From: [REDACTED]
To: [REDACTED]
CC: [REDACTED]
Sent: 3/3/2021 8:44:58 AM
Subject: RE: O8W-PM 35217268, 35224712, 35224713 - Bucks Creek 1101 Phase 1,2&3 - Pre-Engineering Meeting

Subject: O8W-PM 35217268, 35224712, 35224713 - Bucks Creek 1101 Phase 1,2&3 - Pre-Engineering Meeting

PM 35217268 (Phase 1)

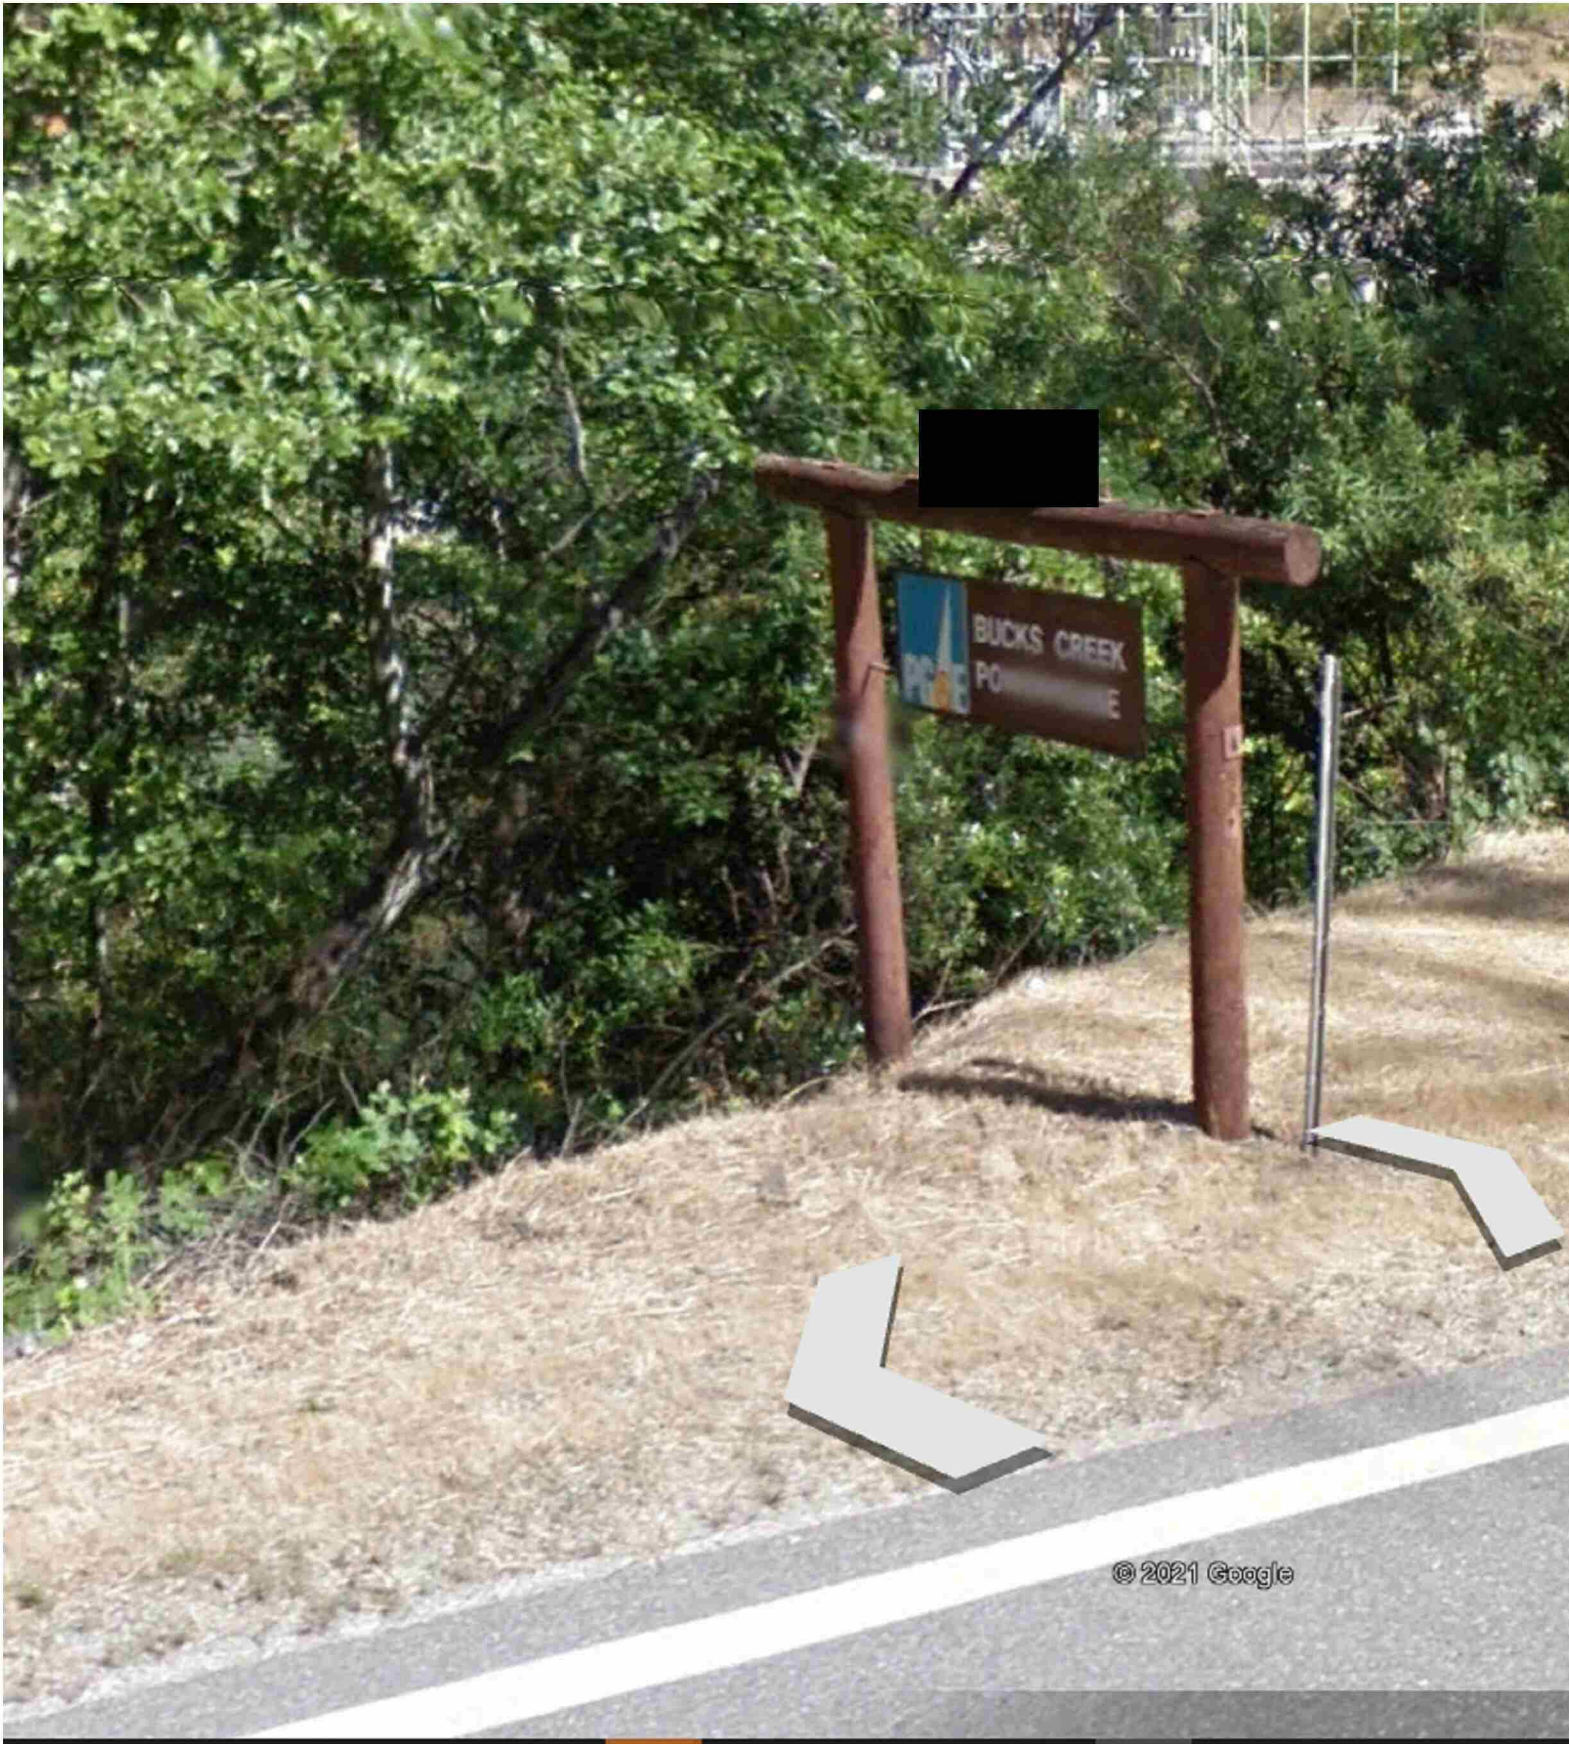
Attached are the 'base-map' limits in a kmz. file. As you will see, we need our base-map to go about ~100' into the tunnel at the south end (see pedestal in picture below....please begin about ~50 beyond this point which is about ~100' beyond the Cresta Dam).

Bucks Creek 1101- PM# 35217268 Overview Map

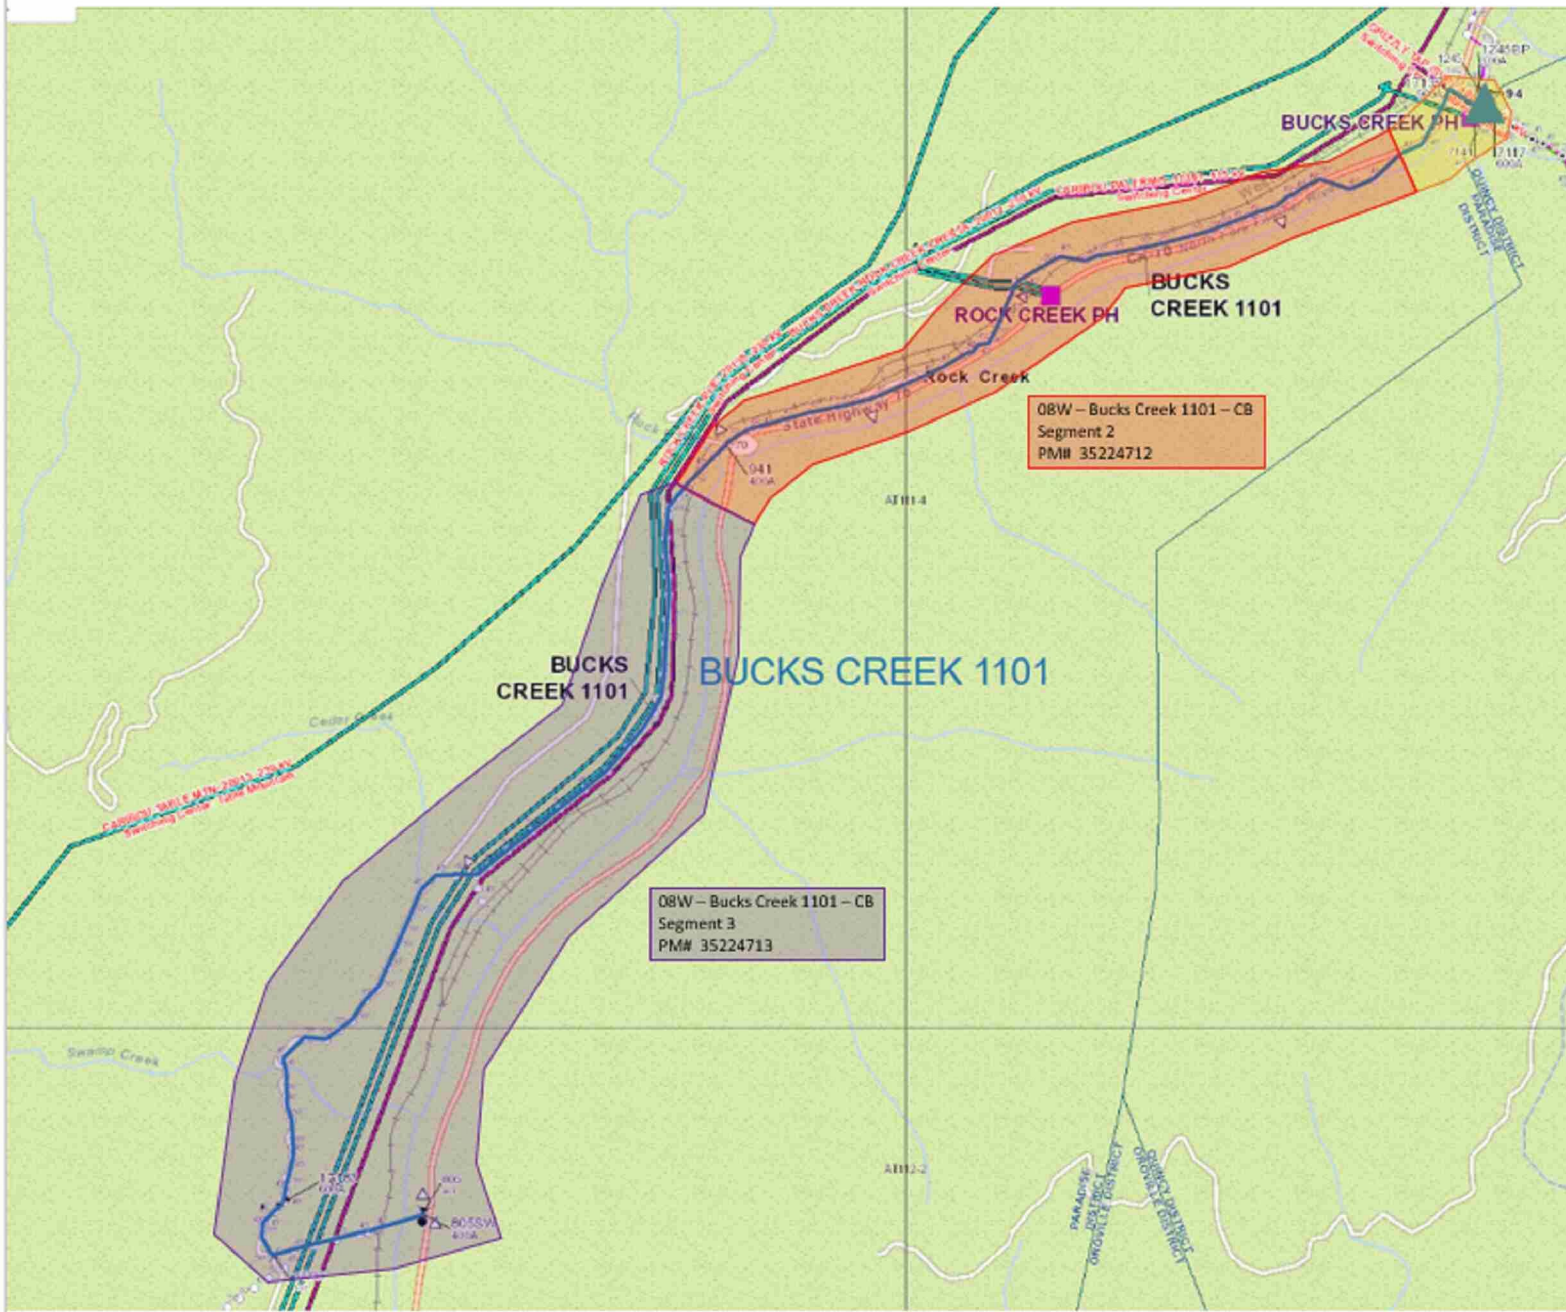
For Bucks Creek there is quite a bit of work surrounding Hwy 70 and we will need a Land Department Base Maps prepared for all 3 Orders. This will delay the EOD dates until these can be developed and provided to the Vendor... We will also need answers to the questions outlined by [REDACTED] below...

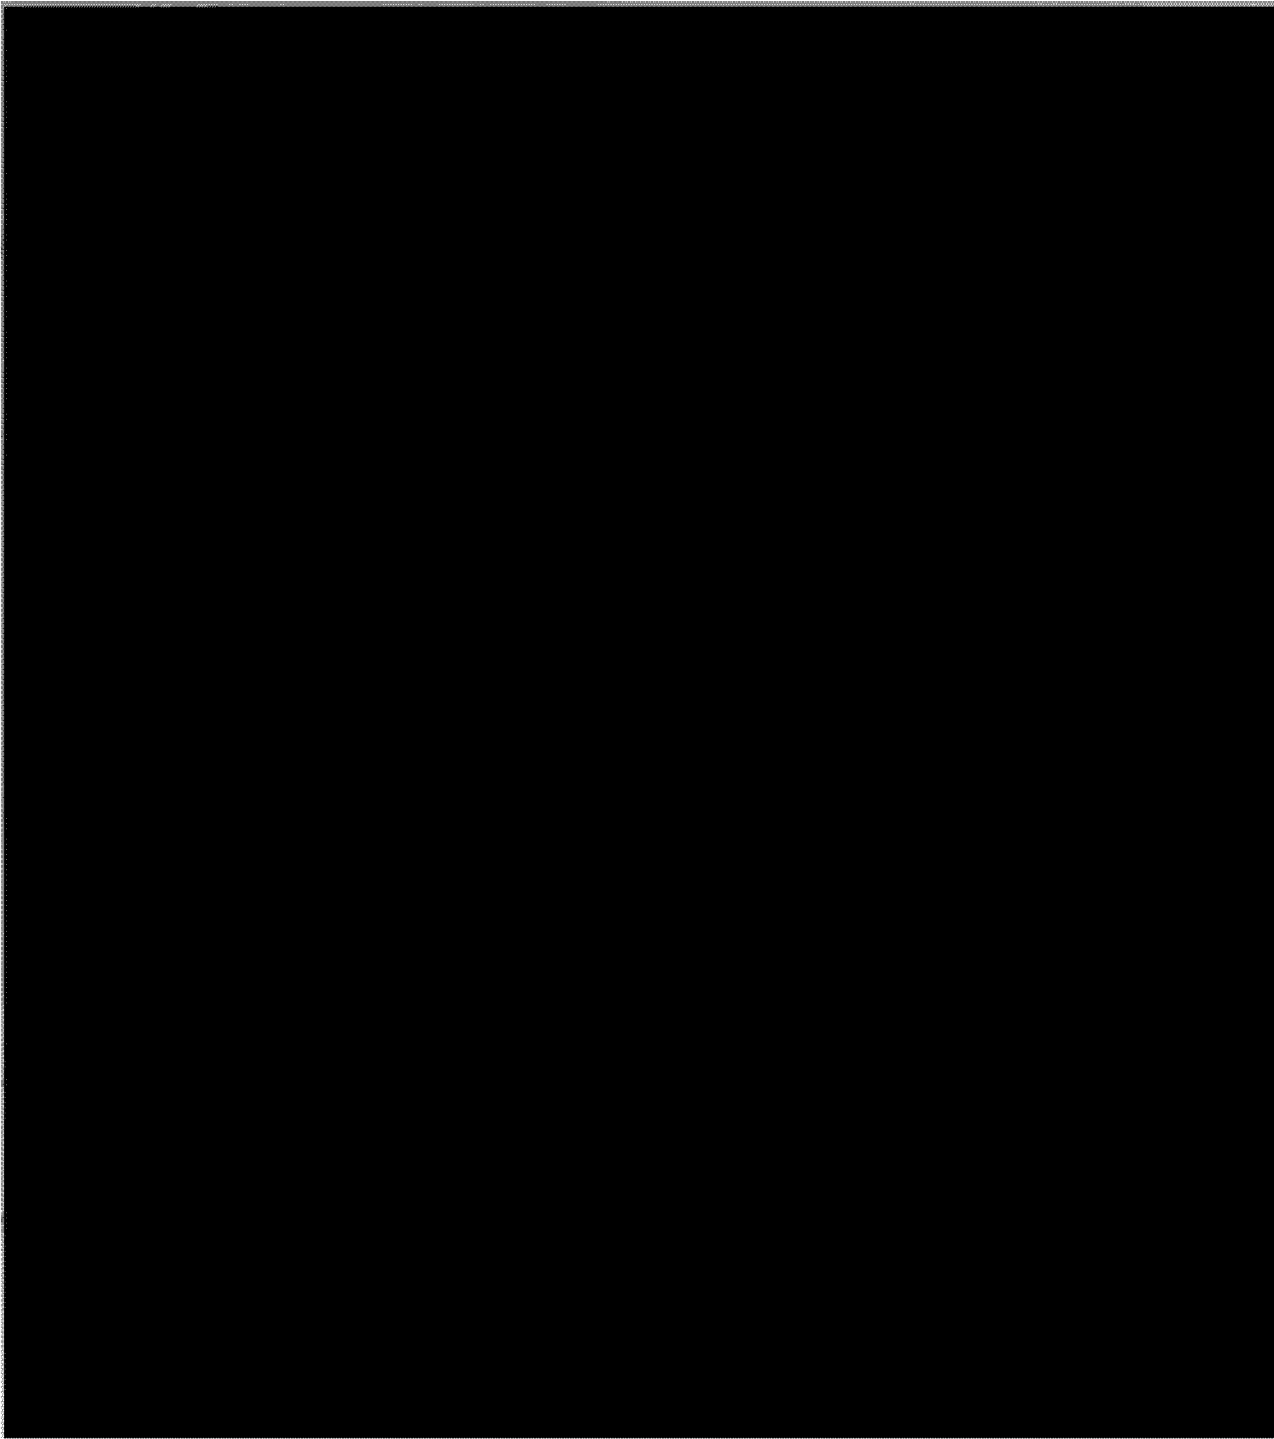
1. We learned the following:
 - a. Sub-Station (per Foreman [REDACTED]) is undergoing its own project under PM 35212441, of which is in UNSC status, and the following locations have 'overlap' scope:
 - i. Location 1, pole is being replaced under Sub PM
 - ii. Location3, pole is being replaced under Sub PM
 - iii. It appears that PM 35212441 will be completed before our O8W project begins, so it is imperative that we work to have their scope match our needs...ASAP. I will take this action with the help of [REDACTED] to supply the details.
2. Location 2 has a bank of three transformers not indicated in any of our scoping documents....do we really need to replace this steel pole?

3. 'Underground' scope between locations 102 and 101 doesn't make sense when the following are considered:
 - a. How does this scope reduce risk?
 - b. Is 'undergrounding this small section 'constructible' when you consider the following:
 - i. Stairway, creek crossing, and proximity to sub-station
 - c. See picture

3. All parties had the same burning question regarding the 'river crossing';
 - a. Why couldn't we move Location 4 to the east side of CA-70 and remove Locations 5, 6, 7, and 8 of the OH-Hardening scope? This would require an increase in OH-UG scope on PM 35224712 of about the same distance of OH-Hardening scope being removed from PM 35217268.
 - b. Here is the basic idea in RED.....the dashed line is proposing UG:
